Construction Division
Additions & Alteration Charges Approval Form

Gulmohar Residency

C-107 (K Kalyan Kumar Venkat)

Details of Additions & Alterations

Description	Direction	Owner & Developer	Date	Prepared By
QC-BLOCK-B-FLAT NO 105-PLUMBING PLAN(B1-TYPE)	N	Modi Realty Mallapur LLP Project Name & Phase Gulmohar Residency	Date Prepared By Approved By	Jaya Pradha Sudhan Moh Modi Properties Pvt Ltd Page: 01/01 (05/11/2020)

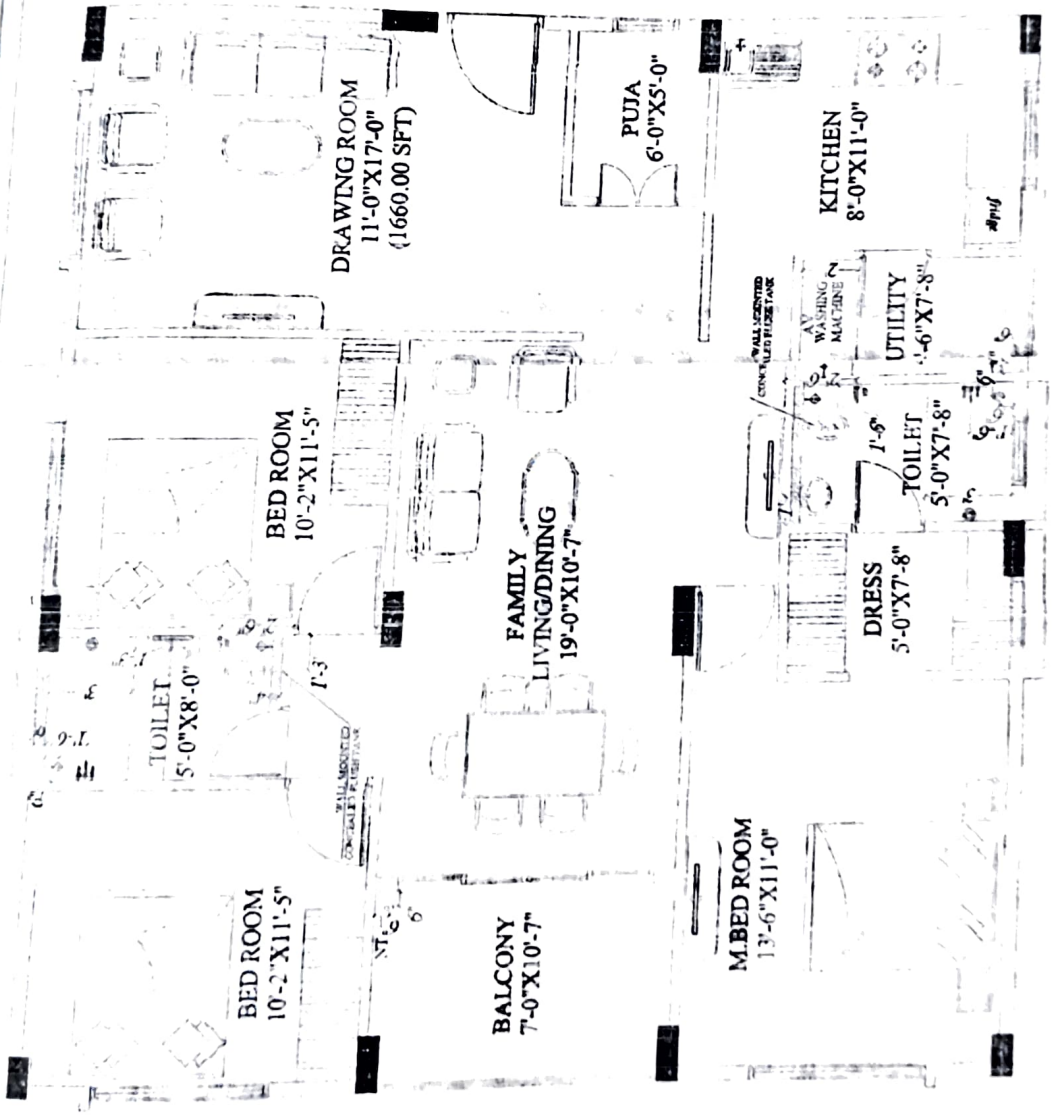
Remarks: 1) one coat of lappam provided, Grey sex point in C-Toi was not a spec drawing. 2) Extra fasteners to be used in utility

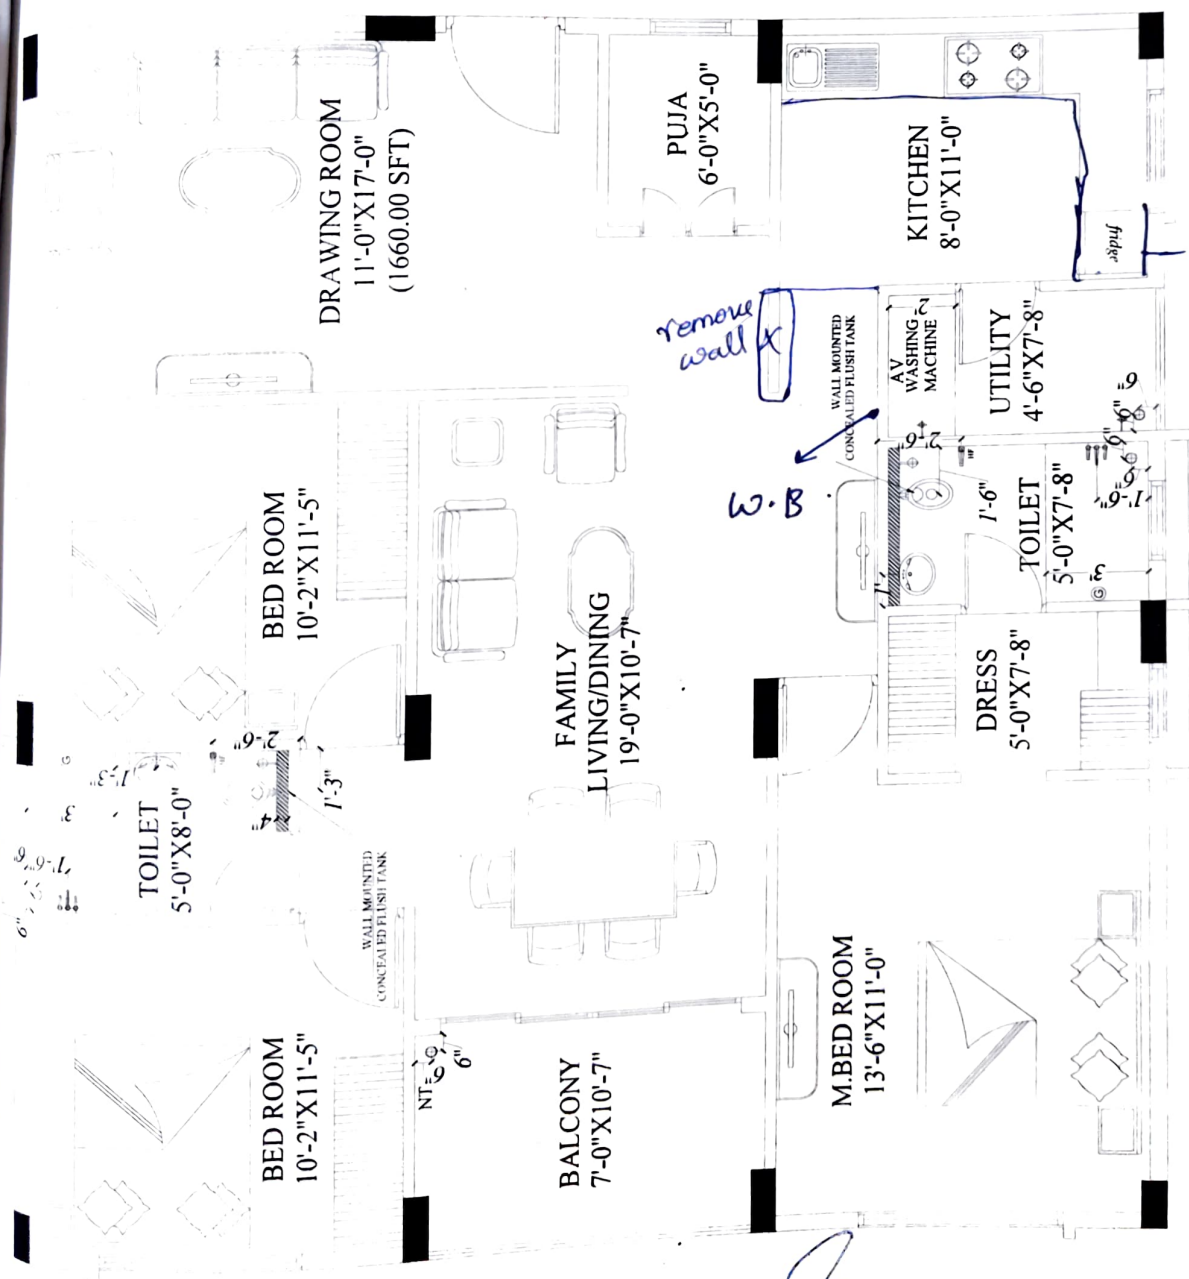
- ① ~~B~~ Luna in C.T (B-108-C.B) in Both
- ② Bathrooms
- ② Indian w-c in C.T.
